USNRC APPLICATION
SUA-1341 License Amendment
Ludeman Project
Converse County, WY

TECHNICAL REPORT
REQUEST FOR ADDITIONAL INFORMATION
RESPONSE PACKAGE: ROUND 2

June 2015

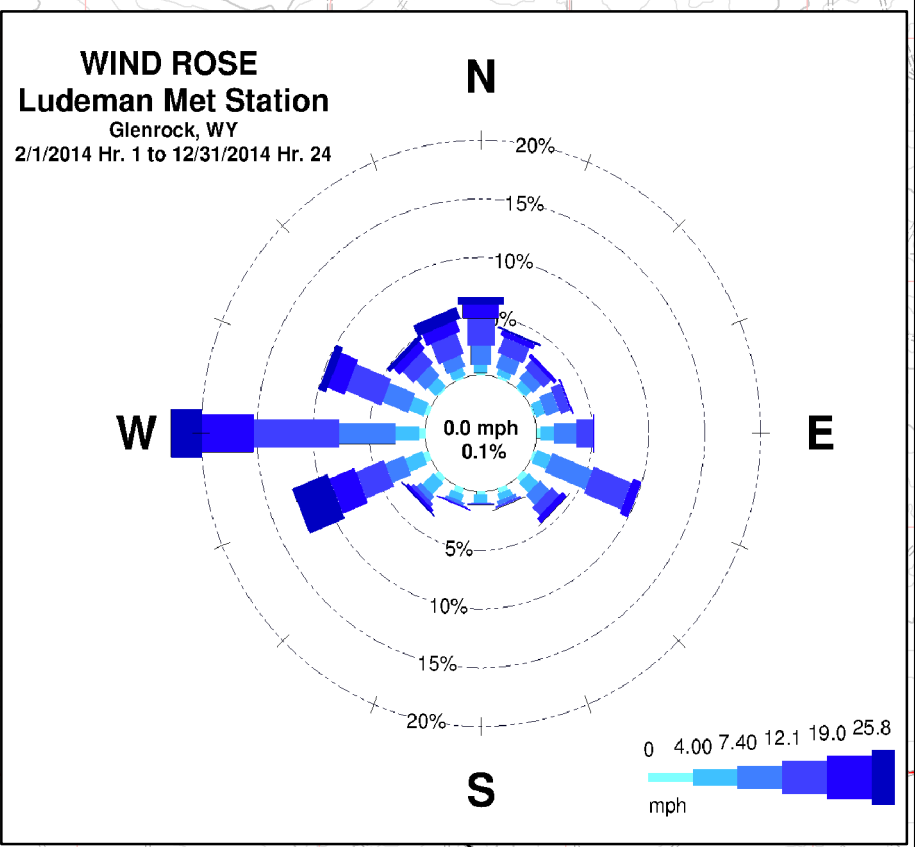
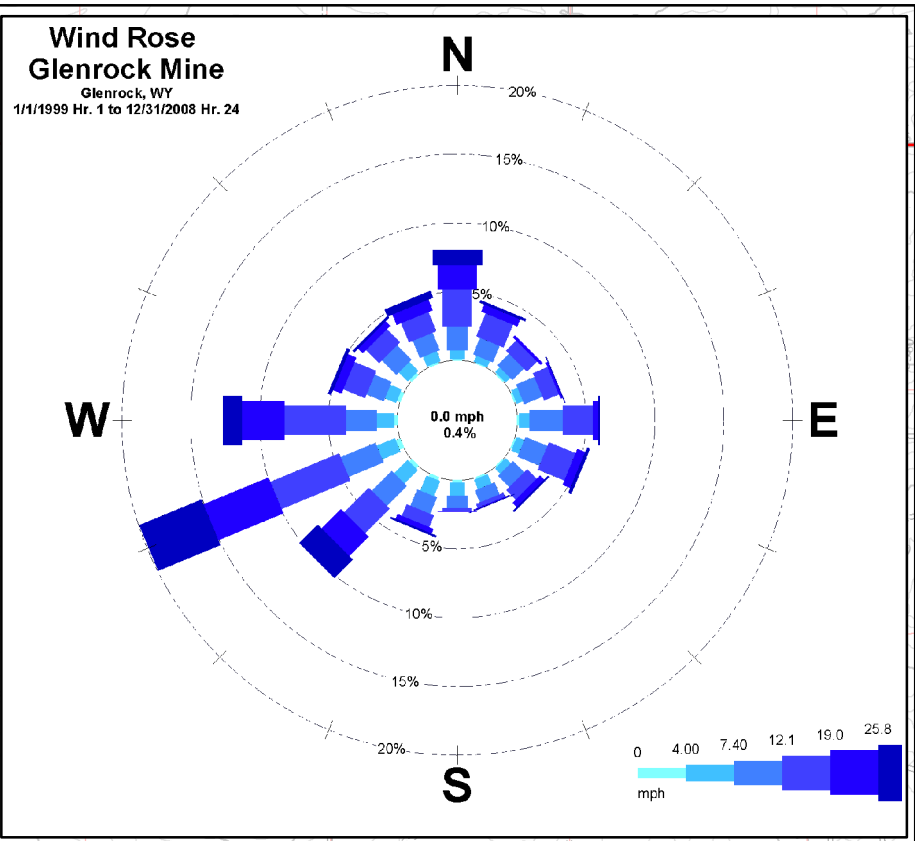
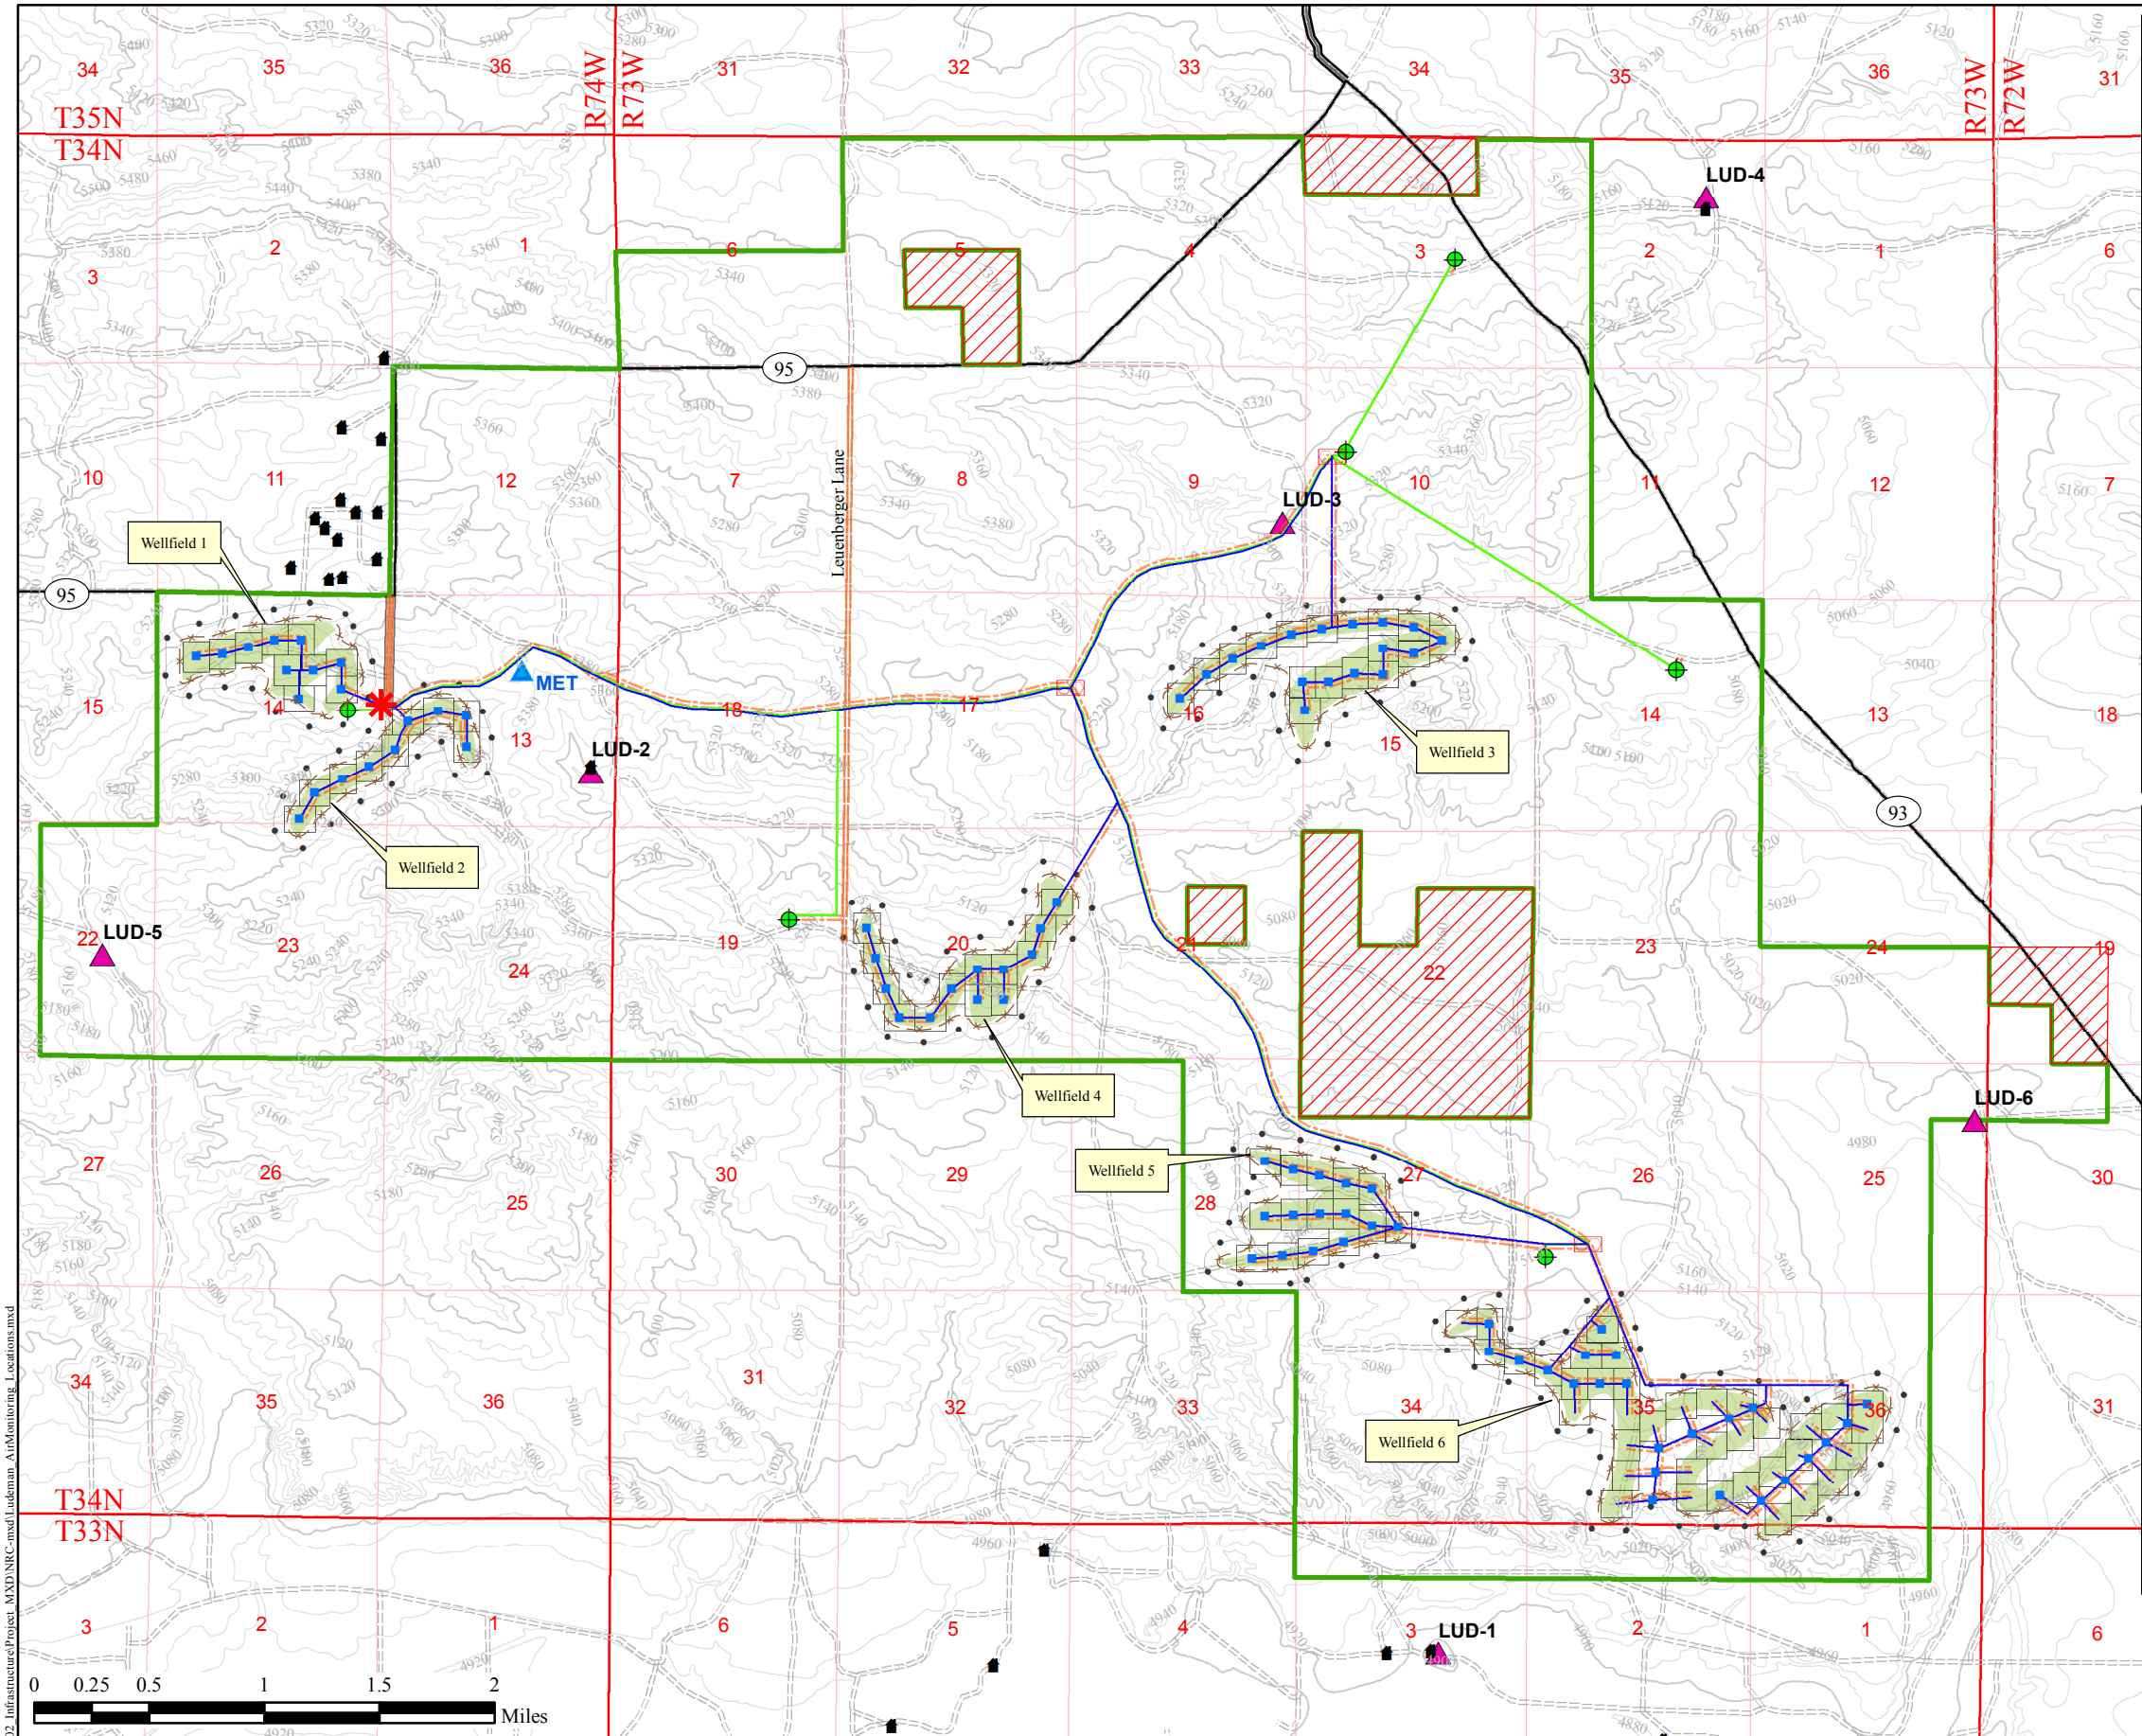
NRC staff seeks information to meet the acceptance criteria in SRP Section 5.7.7.3, acceptance criteria 1 and 2. In review of Section 5.7.7 staff observes the discussion provided and has reviewed Figure 2.9-39 showing various monitoring locations. RG 4.14 Section 1.1.1 asks for the following information when choosing sampling locations:

Uranium One conducted baseline air monitoring for the Proposed Project using five continuous air samplers collecting total suspended particulates. The collected particulate matter was analyzed at the end of each calendar quarter for radionuclides, as specified in Regulatory Guide 4.14. Figure 1 shows the sampler locations with respect to the Ludeman Project boundary, accompanied by the regional and site specific wind roses. The monitoring locations were determined using criteria per Regulatory Guide 4.14. Monitoring location LUD 3 did not include an air particulate sampler, only data on radon and gamma baseline concentrations were collected at this monitoring location. The original regional evaluation weather data (Glenrock Coal) used to select the baseline sampler locations was based on the criteria outlined in RG 4.14, Section 1.1.1:

Criteria 4: The nearest structure which could potentially expect occupants with the highest predicted airborne concentration of radionuclides due to milling operations is LUD-2 which is located at a dwelling approximately one mile downwind (prevailing wind direction) from the proposed satellite plant.

The Negley subdivision is approximately 0.5 miles north of the satellite plant site; however, wind rose from both the regional data set as well as the onsite meteorological station (Figure 1) shows that southerly winds towards the Negley subdivision are extremely uncommon. Therefore, the radionuclide concentrations are expected to be higher at the LUD-2 location. Given the close proximity of the Negley subdivision, Uranium One will establish a sixth air monitoring station for baseline air particulate monitoring at or near the project boundary and north of the satellite plant site.

At least one structure where predicted doses exceed 5 percent of the standards was LUD-4 which is located approximately six miles downwind from the satellite plant site and near a residence outside the project boundary. A remote location that represents background conditions at the mill site (satellite) LUD-5 is located southwest of the satellite plant site. Since prevailing winds are westerly and west-southwesterly with a secondary mode from the east-southeast, impacts from the proposed satellite plant at LUD-5 are expected to be minor.
